Subject: NYM/2021/0049/LB Additional details E11893-23 NYMNPA amendments 28.06.21

CLIENT: Christine Maw
 PROJECT: Barn South East of The Granary Suffolk YO13 0BJ

DRAWING: Proposed Plan and Elevations

DRAWING No: D11893-03 REV: E

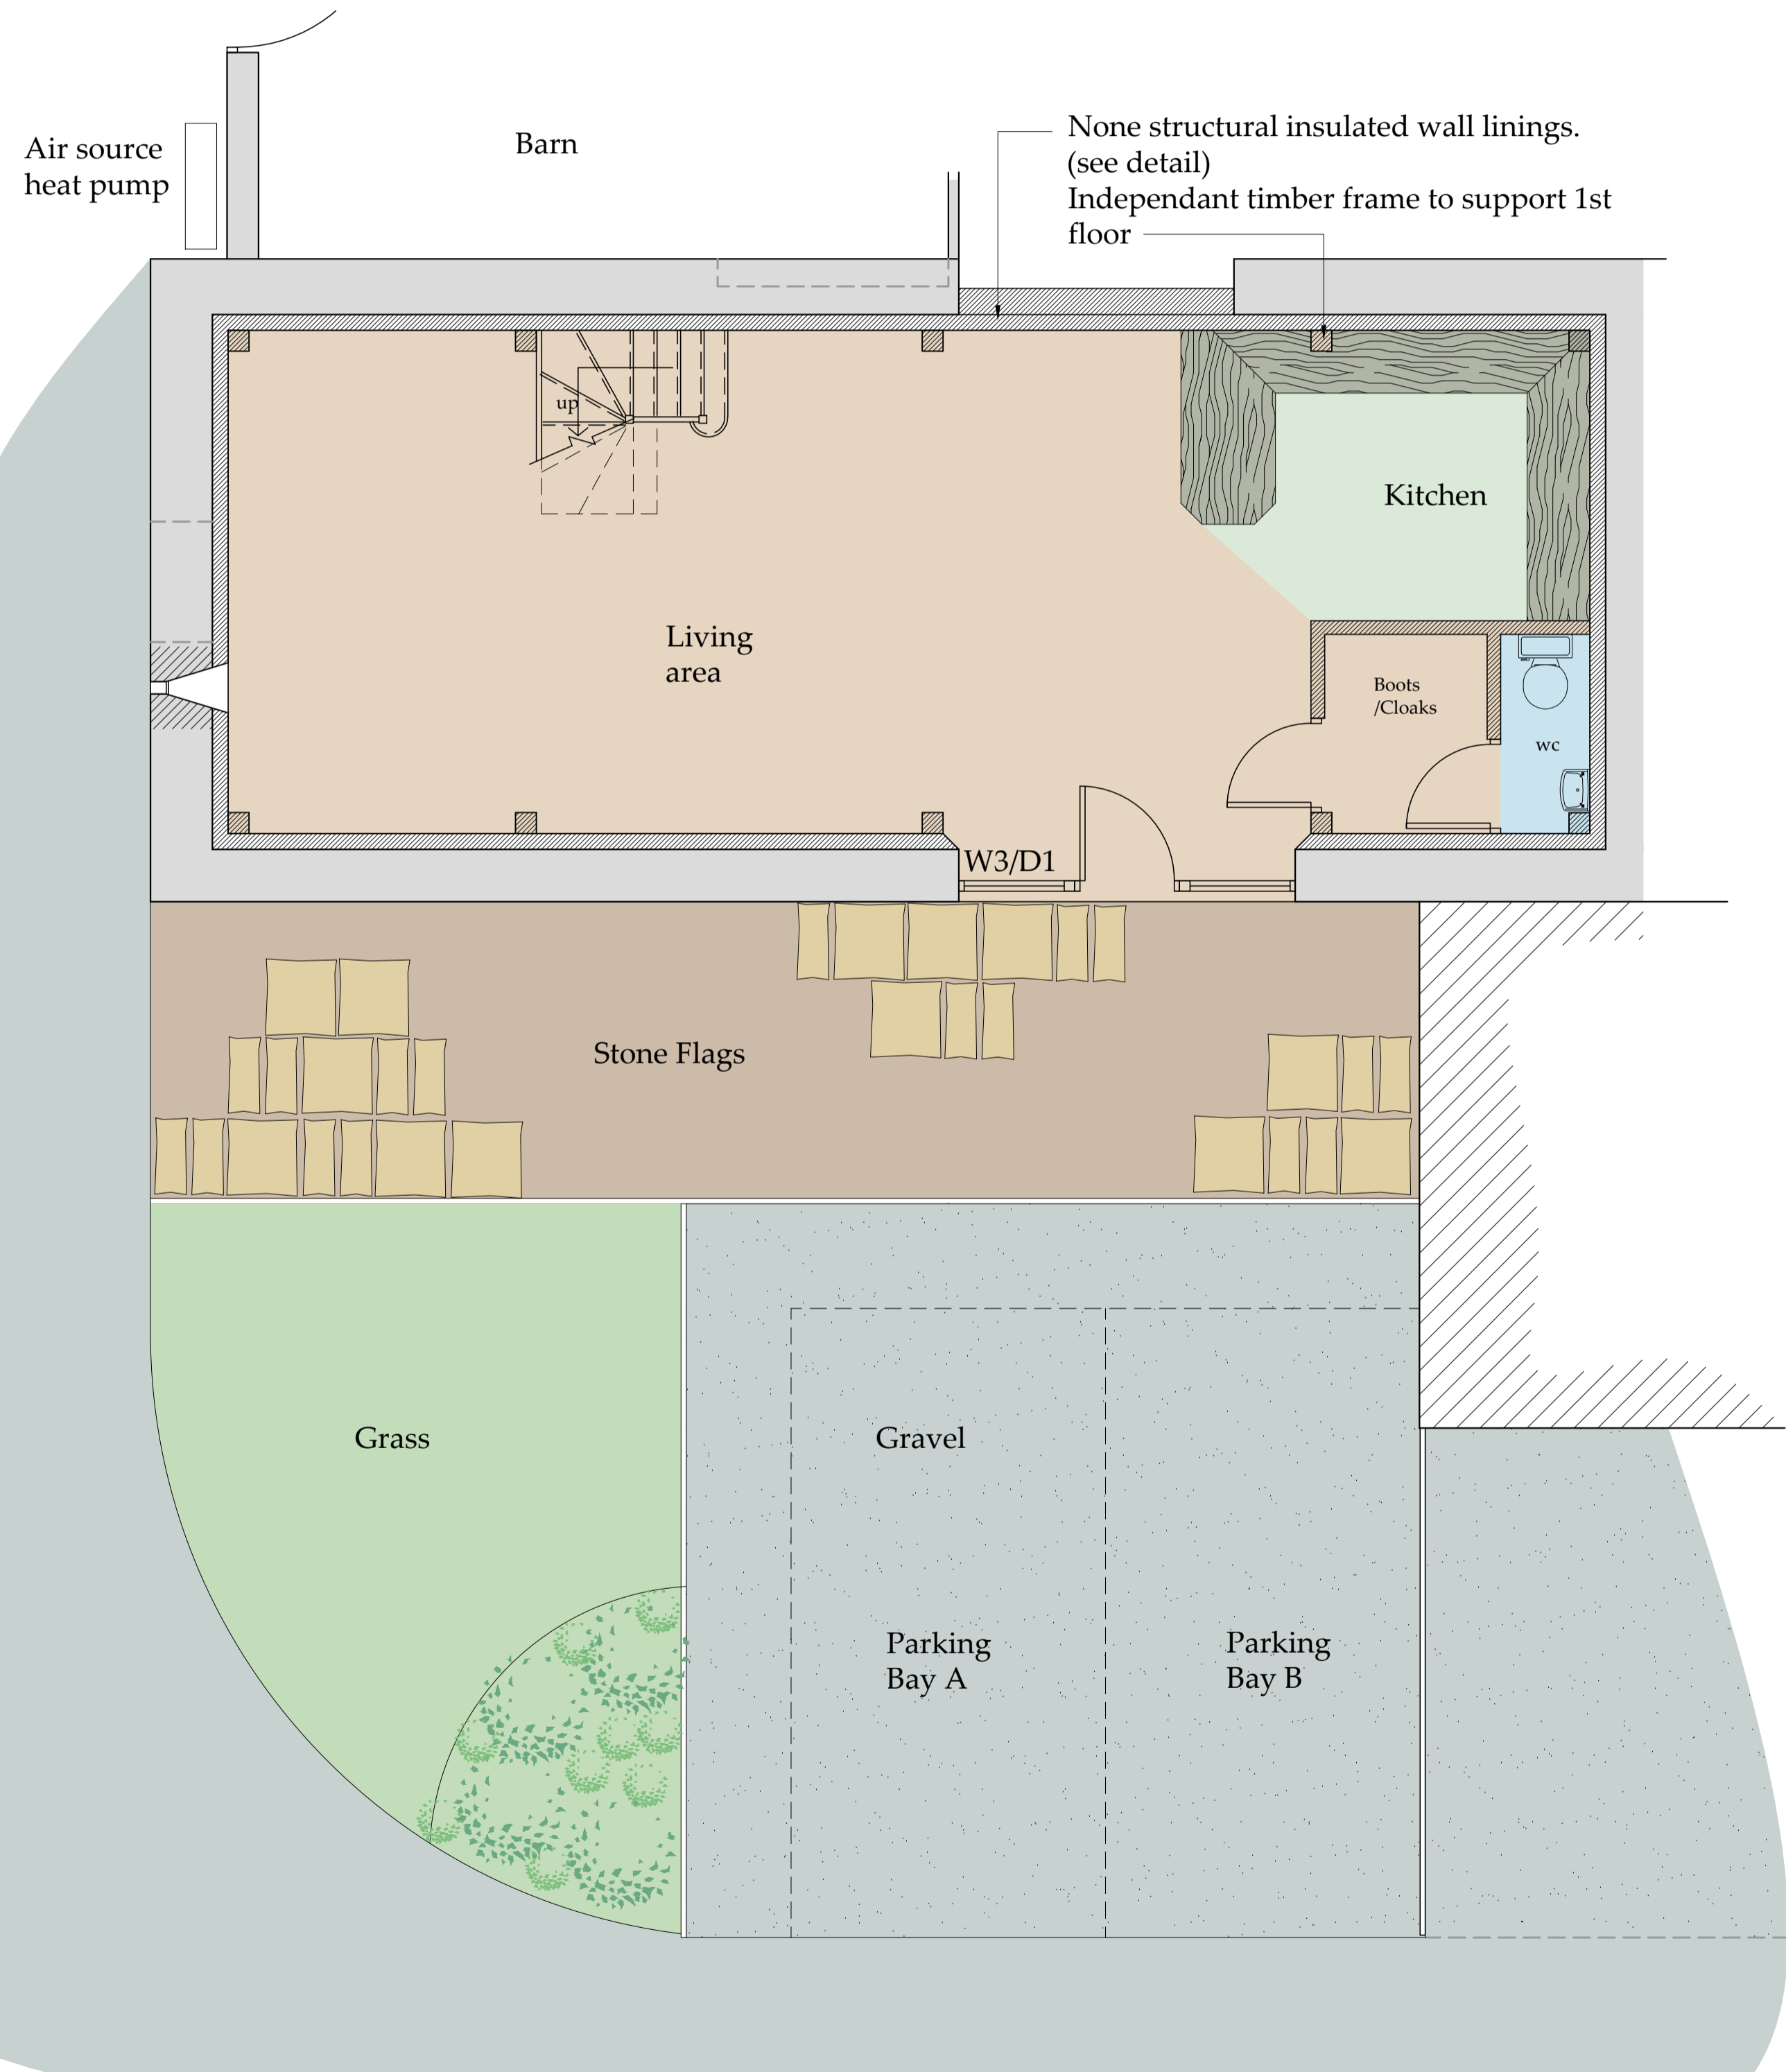
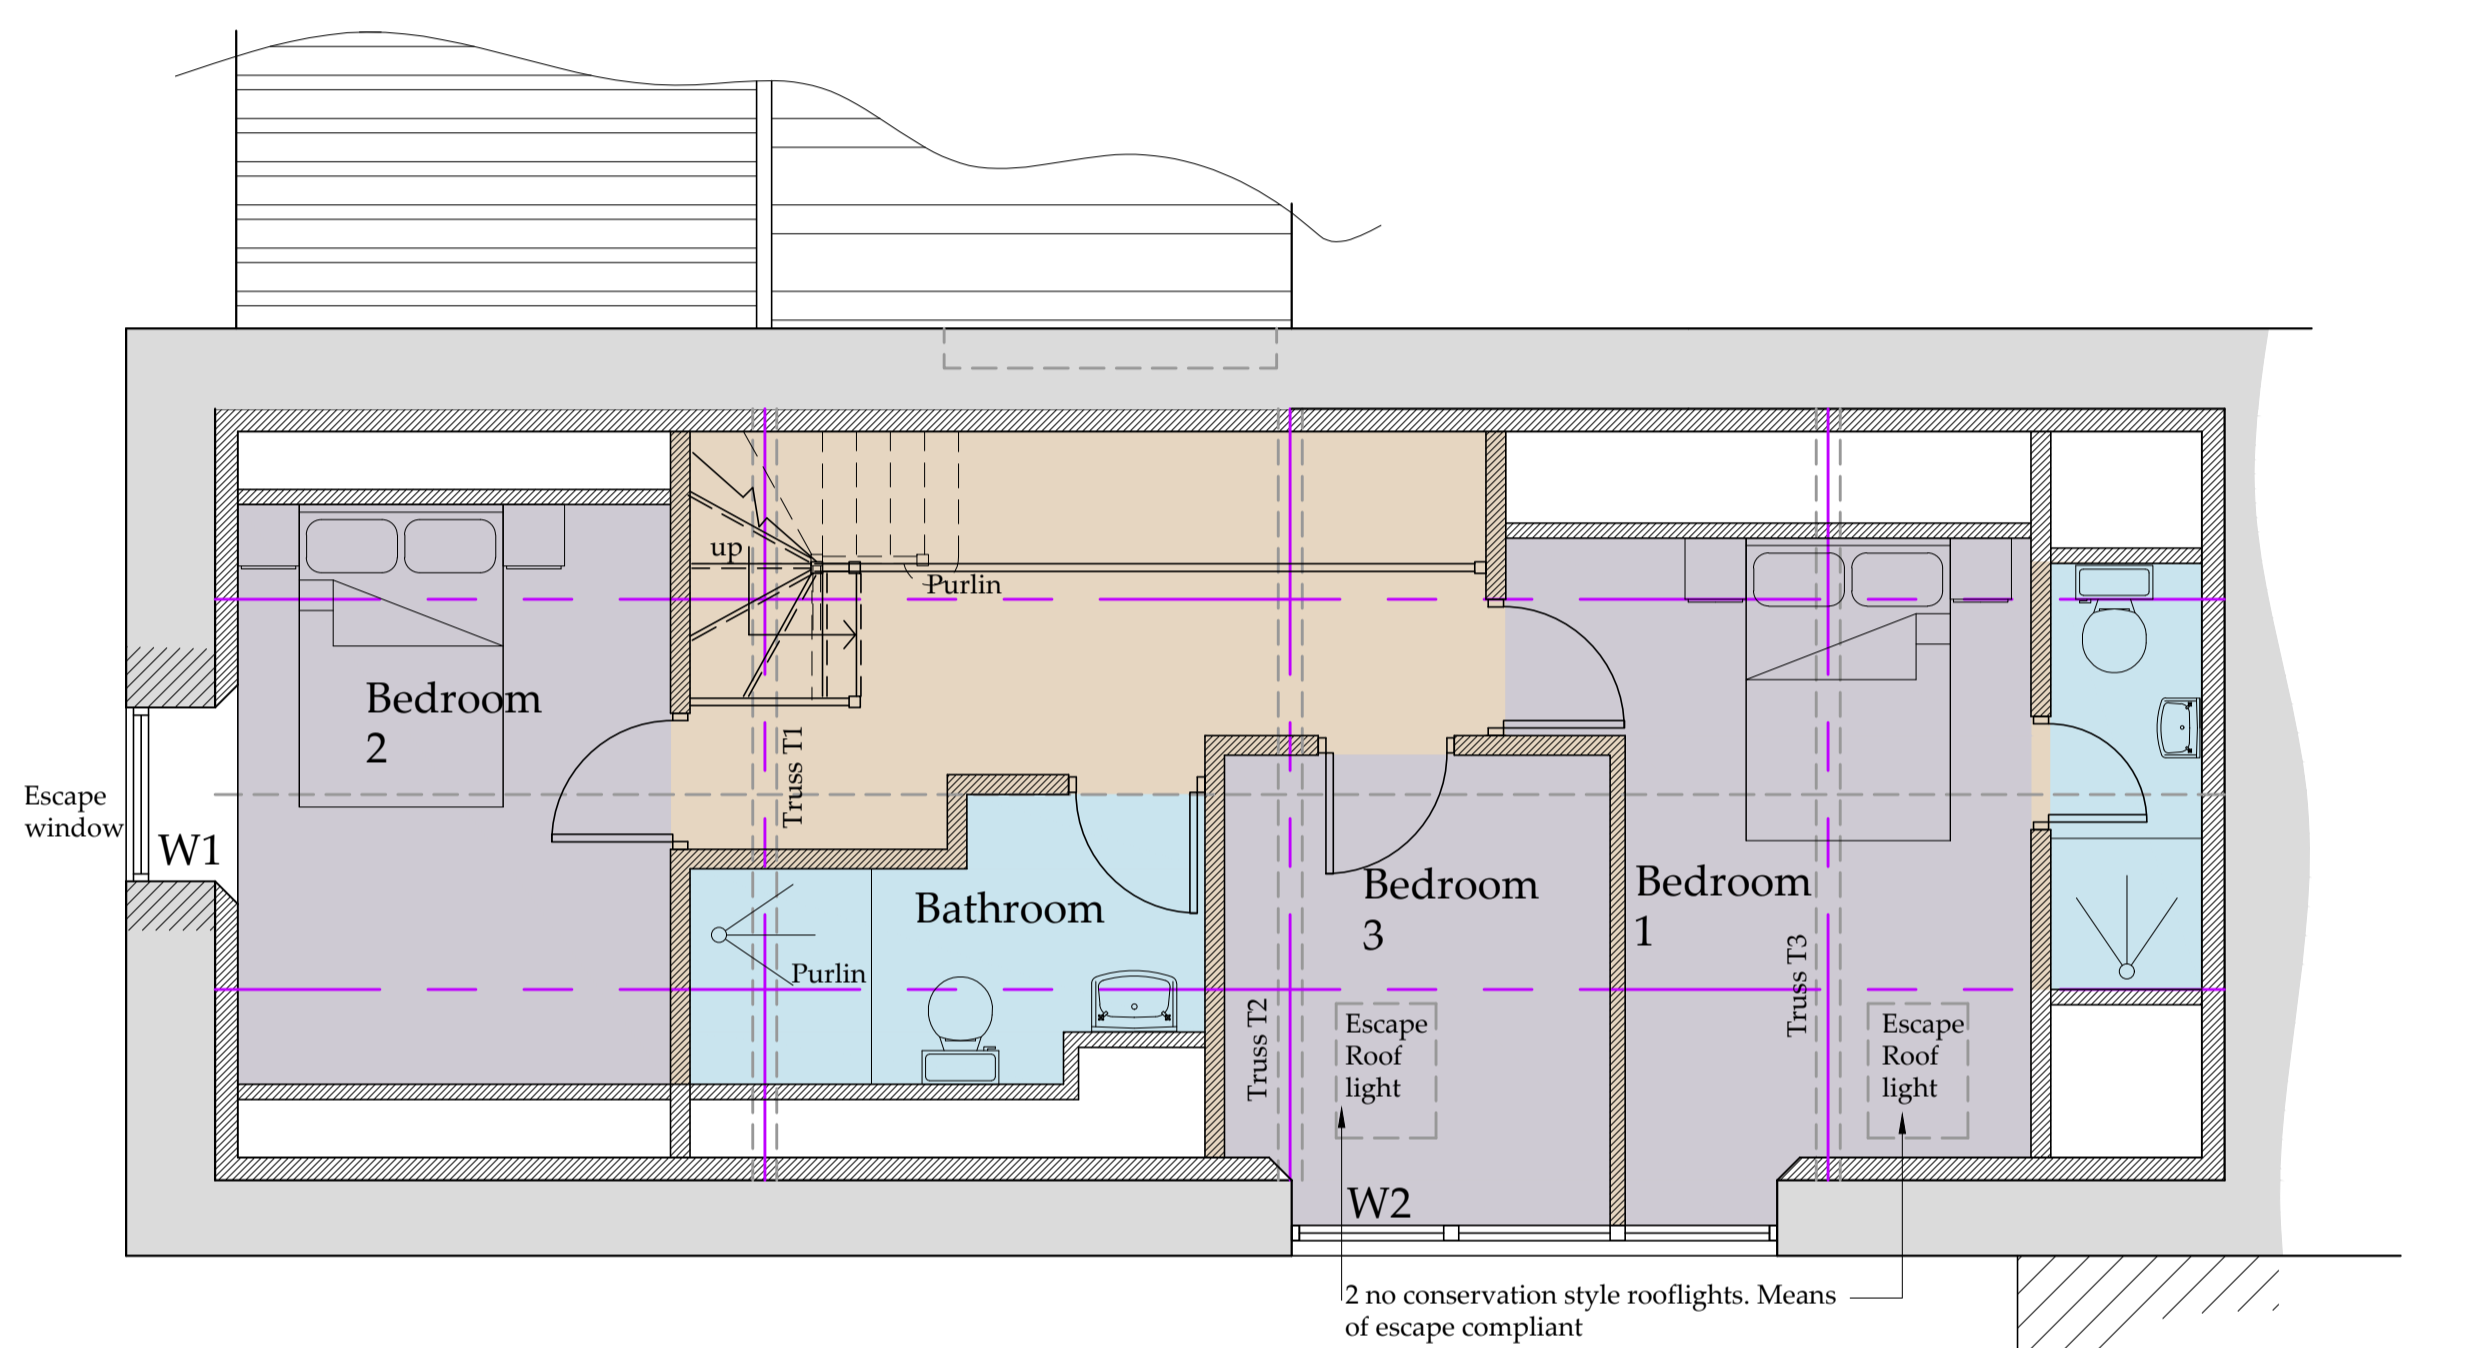
Drawing 03E now shows the principal for works to the inside of the building
First Floor will be fully supported on a structural timber frame which is independent of the existing walls and self supporting. Individual pad foundations will need to be positioned below each post, please note the floor is a modern concrete finish with dpm.

Wall lining detail
- (Historic England, Energy Efficiency and Historic Buildings)
Scale 1:20

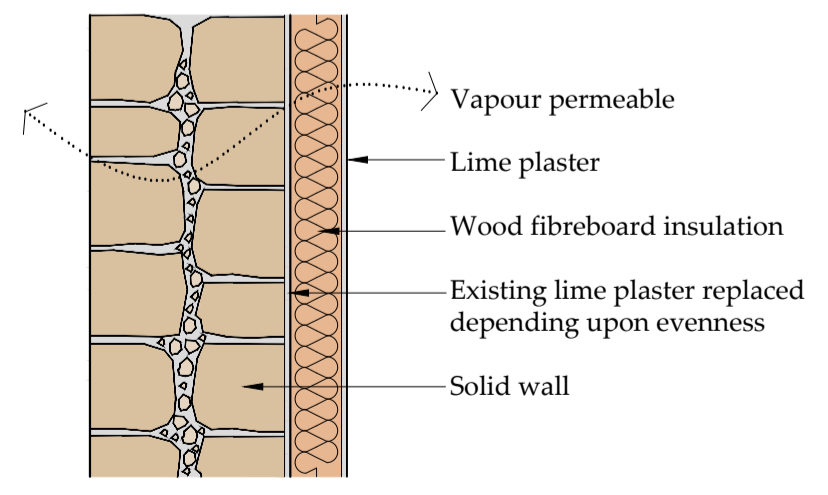
The internal face of external walls will be lined with wood fibreboard and lime plaster as the detail on the drawing
